Re Profile Park Power Plant– Planning Compliance (SD21A/0167)

**Profile Park Power Plant
Planning Compliance Report**
Application Reference: SD21A/0167

Planning Compliance Report Application Reference: SD21A/0167

Document Control Sheet	
Document Reference	11069
Report Status	Issue
Report Date	05/10/2022
Current Revision	D02
Client:	GREENER IDEAS LIMITED
Client Address:	C/O Centrica Business Solutions, 1 Seapoint Building, 44-45 Clontarf Road, Dublin 3, D03 F4A7
Project Number	11069

Appendix 4 – Updated Drainage Plans

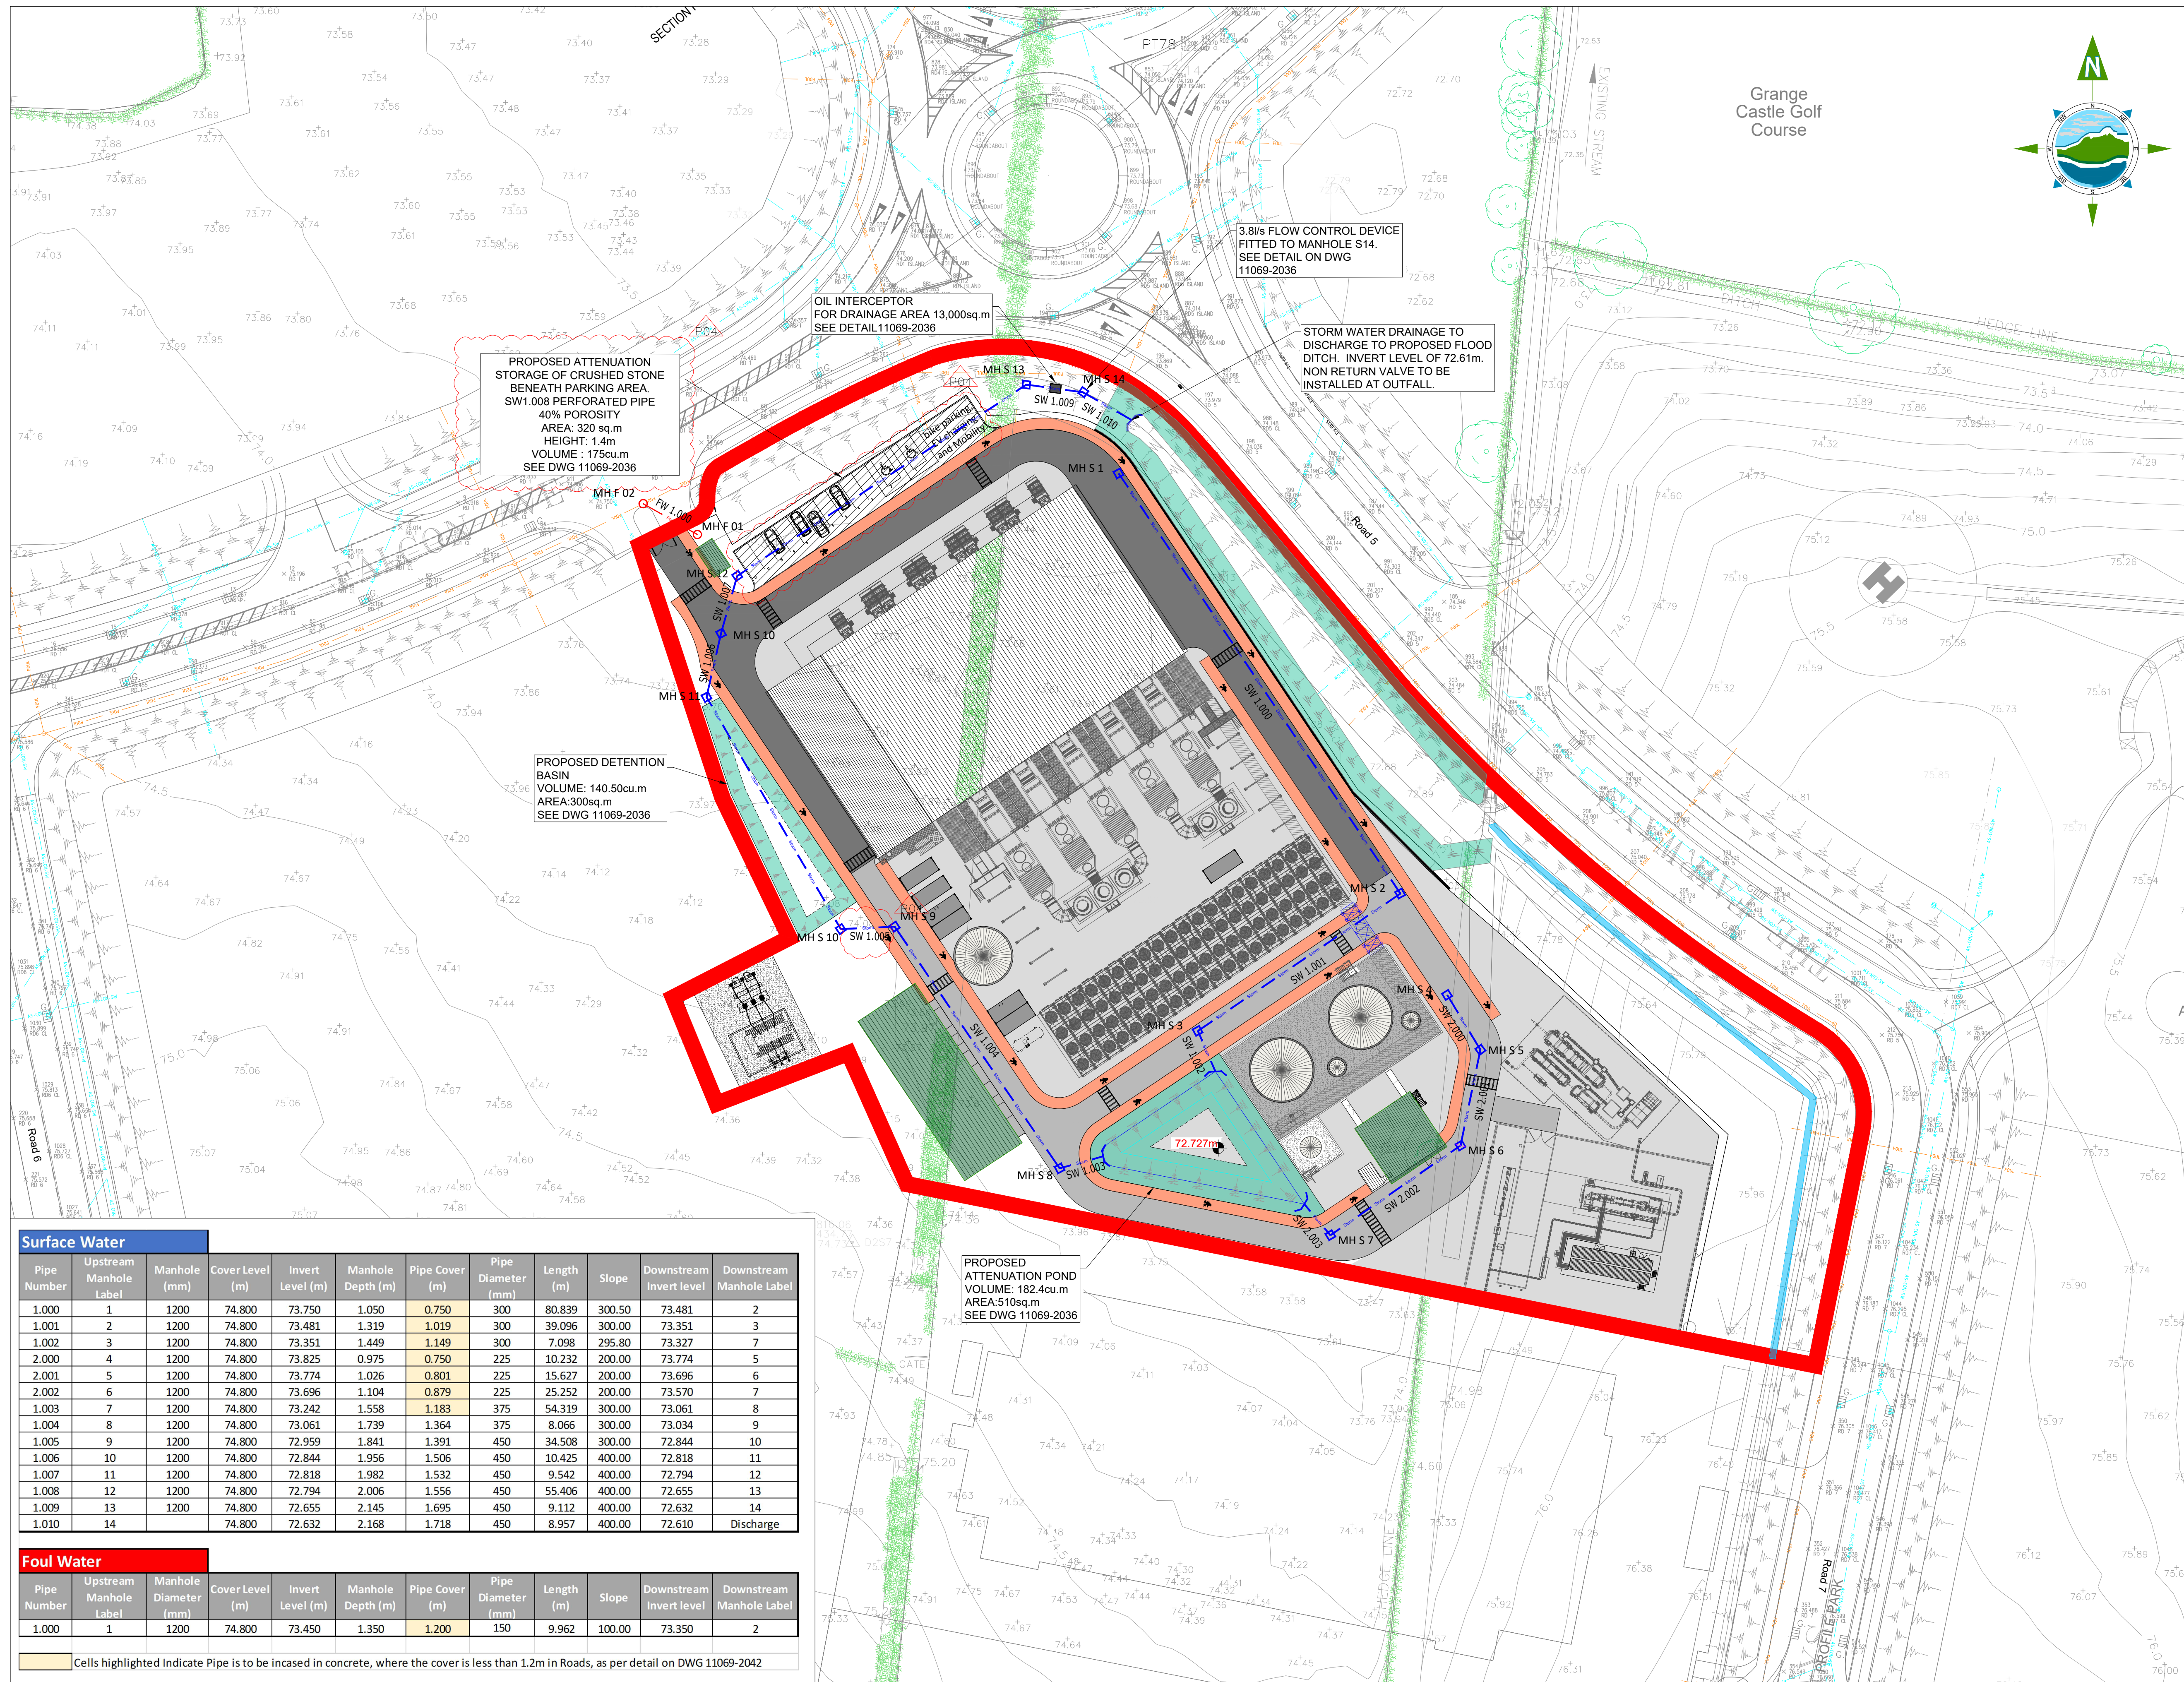
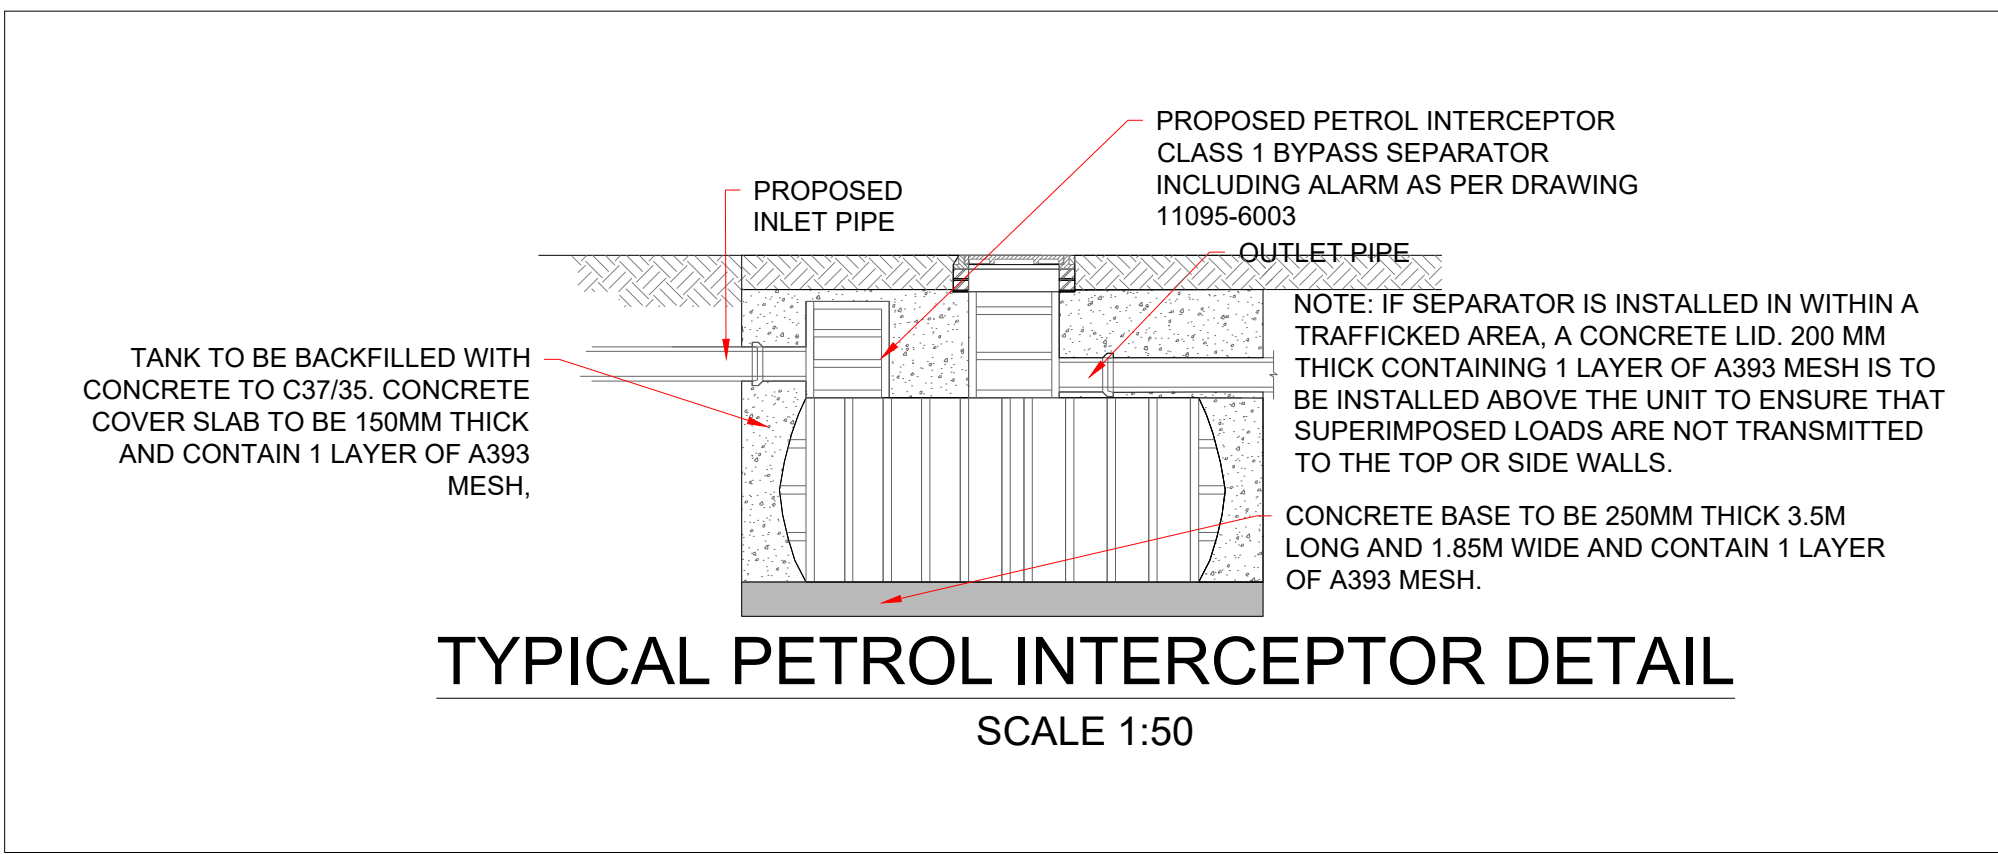
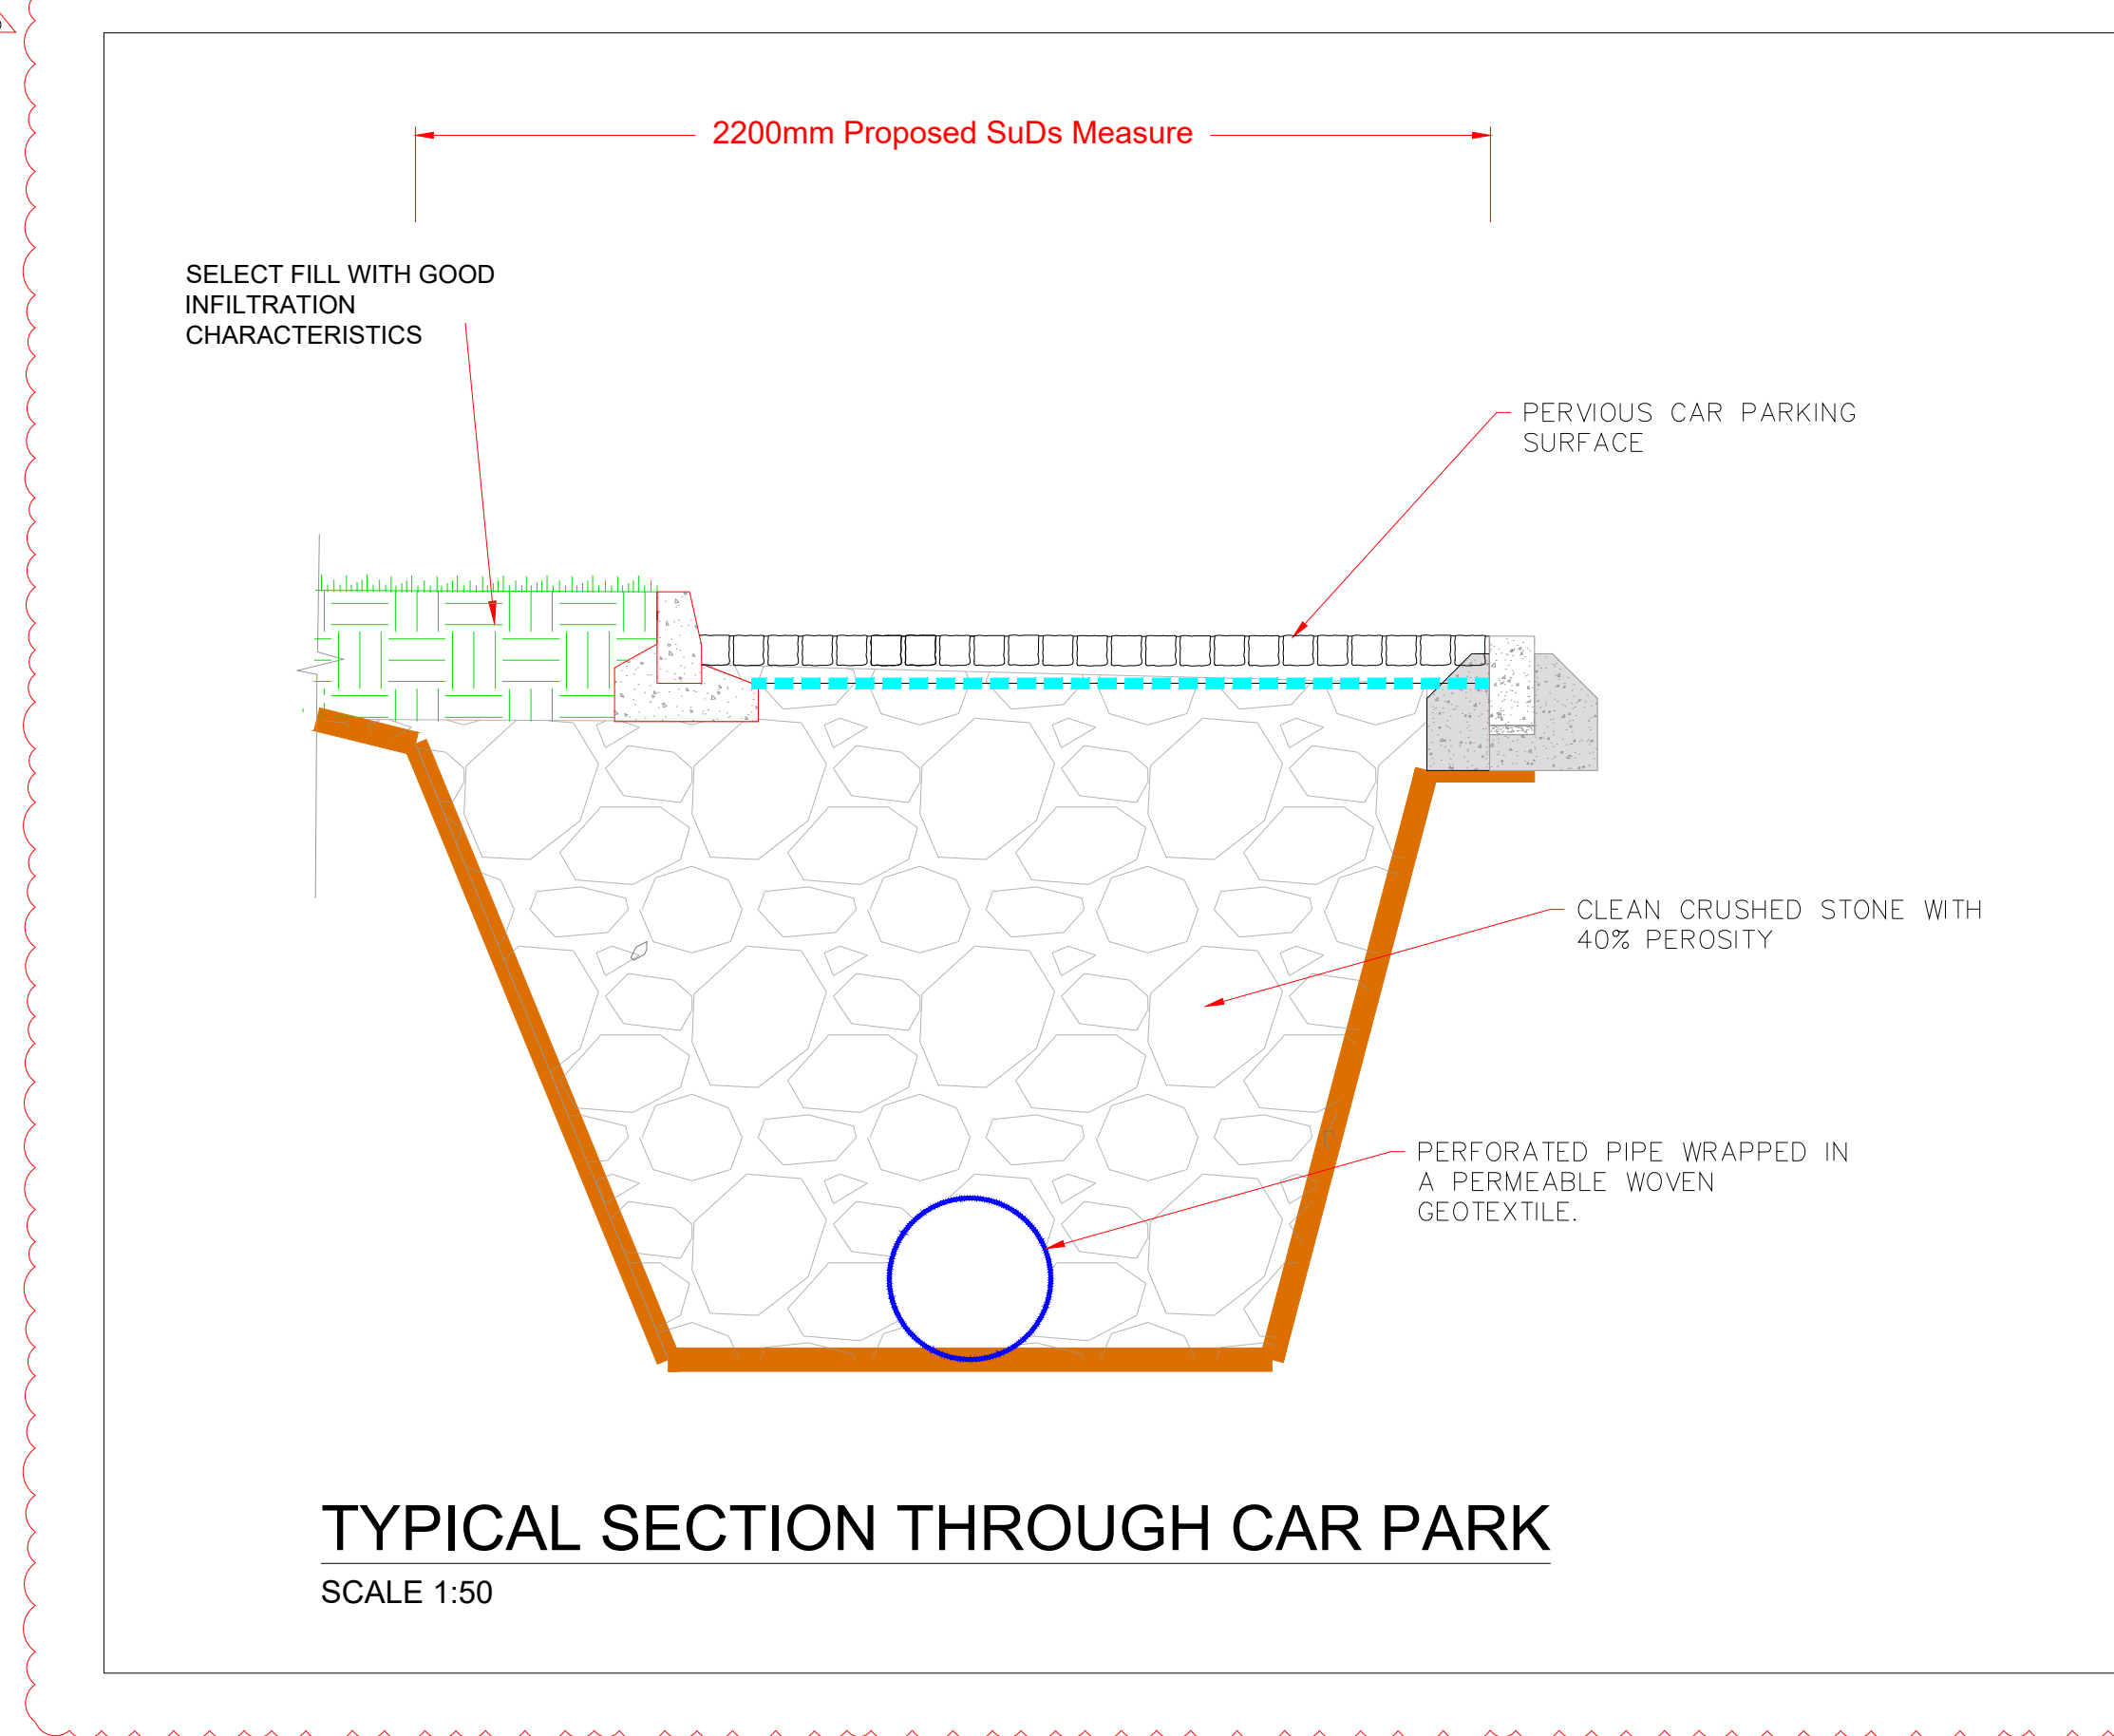
- (a) Prior to commencement of development, the applicant shall submit a drawing showing where and how surface water discharge from site will be limited to a maximum of 3.8 litres/second.
- (b) Prior to the commencement of development, the applicant shall submit revised drawings which provide adequate SuDS and omit the underground attenuation and petrol interceptors, unless otherwise agreed in writing by the Planning Authority.
- (c) All fuel storage proposals on site shall comply with the Greater Dublin Regional Code of Practice for Drainage Works Section 17. All process water and any effluent from the development shall not discharge to the surface water drainage network.

With regards to item (a) above, please see Appendix 4 for an updated site layout plan no. 11063-2010_P04, which shows the location of the proposed Hydrobrake at manhole S14. The design head for the Hydrobrake is 1.80m.

With regards to item (b) above, the originally proposed underground attenuation tank has now been omitted from the design and replaced with a cleaned crushed stone detention basin to allow for storage of surface water runoff, treatment and infiltration of stored water into the groundwater. Please see Appendix 4 for updated plan no.s 11069-2010_P04 and 11069_2036_P05.
